JOSEPH M. FARLEY NUCLEAR PLANT, UNIT 2

AMENDMENT TO FACILITY OPERATING LICENSE

Amendment No. 79
License No. NPF-8

ATTACHMENT TO LICENSE AMENDMENT NO. 79

Figure 2.1-1 Reactor Core Safety Limit
Three Loops in Operation

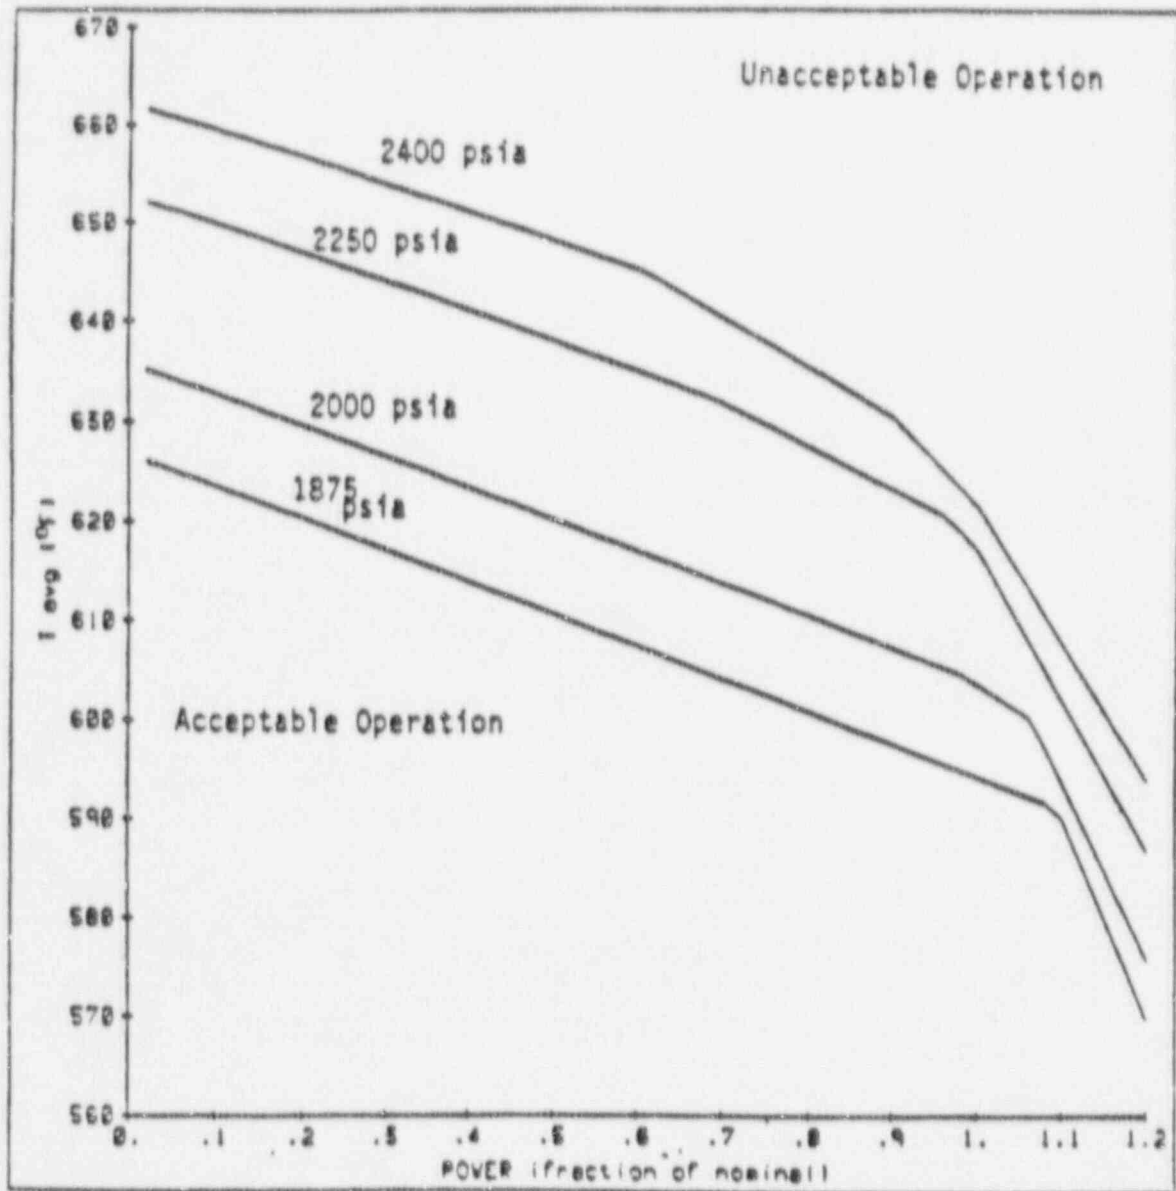
Replace the following pages of the Appendix A Technical Specifications with the enclosed pages. The revised areas are indicated by marginal lines.
